# Agenda Item 9.

App No : 18/06215/FUL App Type : FUL

Application for : Change of use of land used as an ancillary car park for Marlow Rugby Club to allow the car park to be used by Globe Business Park Monday to Friday (8am-6pm) and solely by Club Members outside of these times with new cycle parking for Marlow Rugby Club

At Marlow Rugby Club, Riverwoods Drive, Marlow, Buckinghamshire SL7 1QU

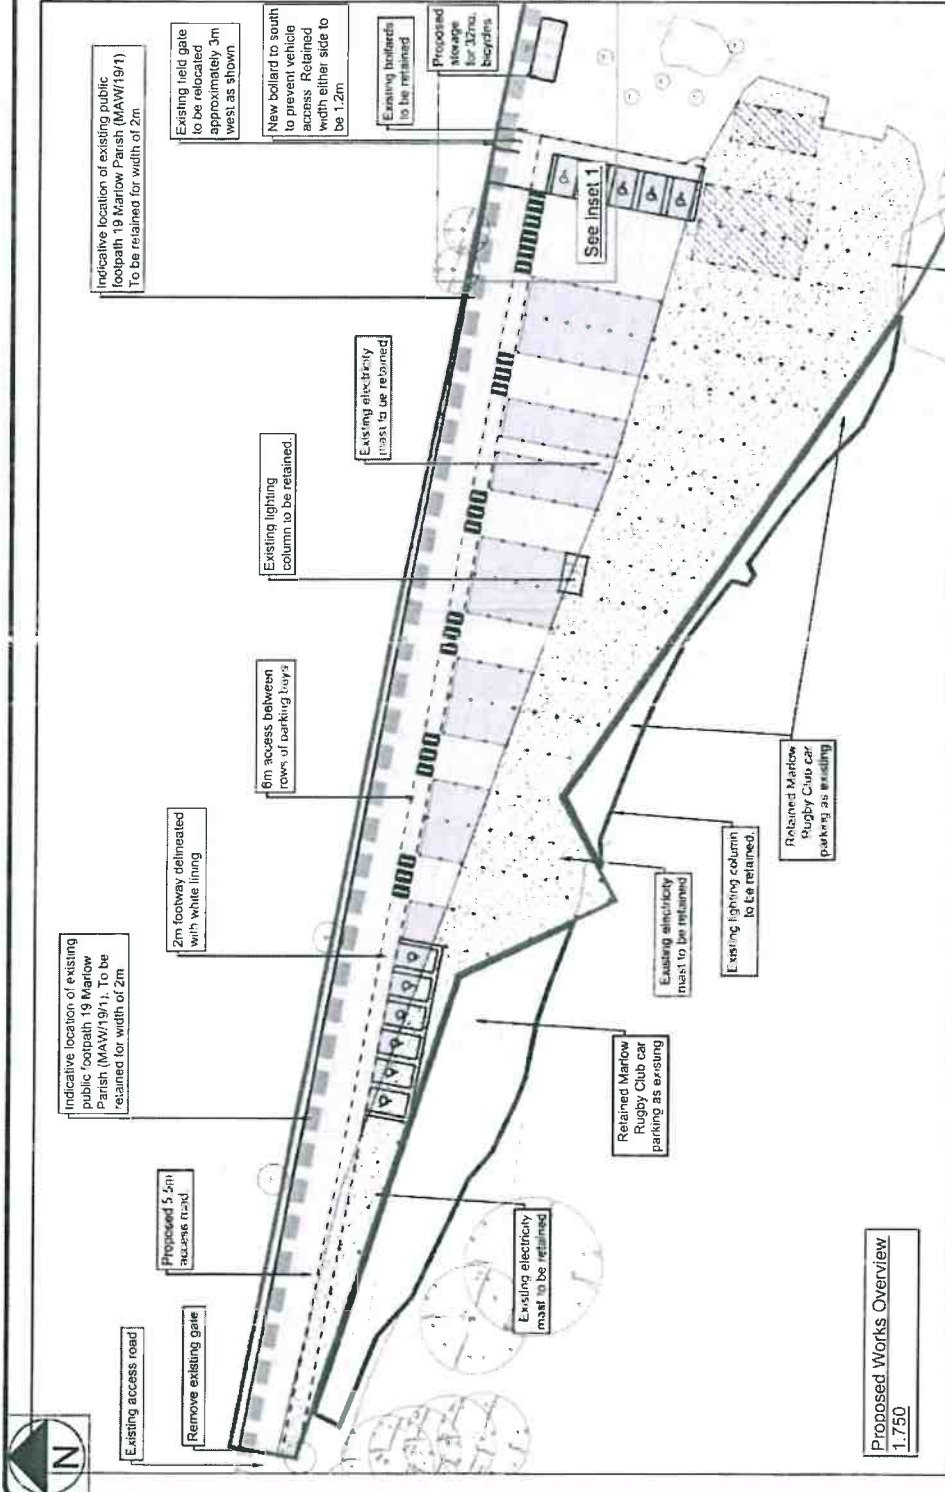
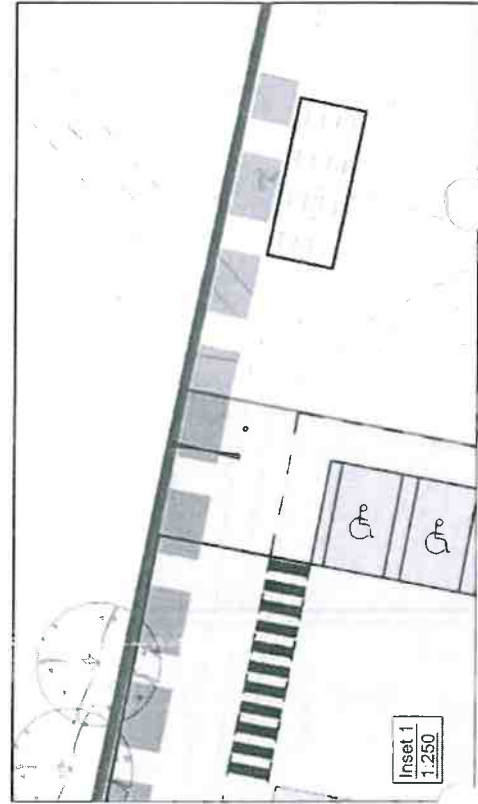
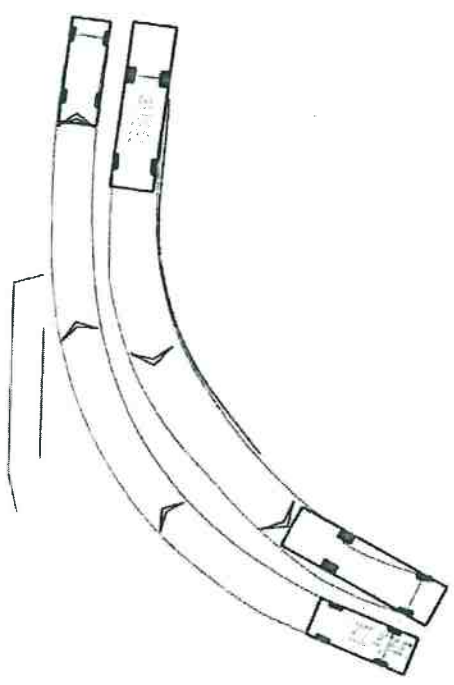
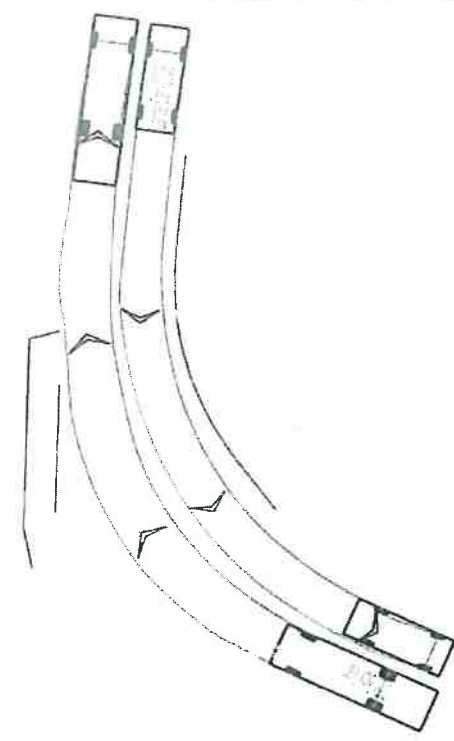
Final Comments: With reference to Drawing SK04 (Rev E), into which I was copied by email on 10th October 2019 from Mike Fuller, Cotswold Transport Planning, I can confirm the amendments now address all my previous concerns regarding the application. I am content there will be no negative impacts on walkers using the public footpath through the site.

The applicant has submitted a plan for works proposed to be carried out upon the public highway at Gossmore Lane adjacent to the railway pedestrian crossing. These proposals include the creation of a dropped kerb with tactile paving informal highway crossing. The proposed informal crossing point is considered capable of safely accommodating the likely increase in pedestrian movements between the application site and Globe Business Park.
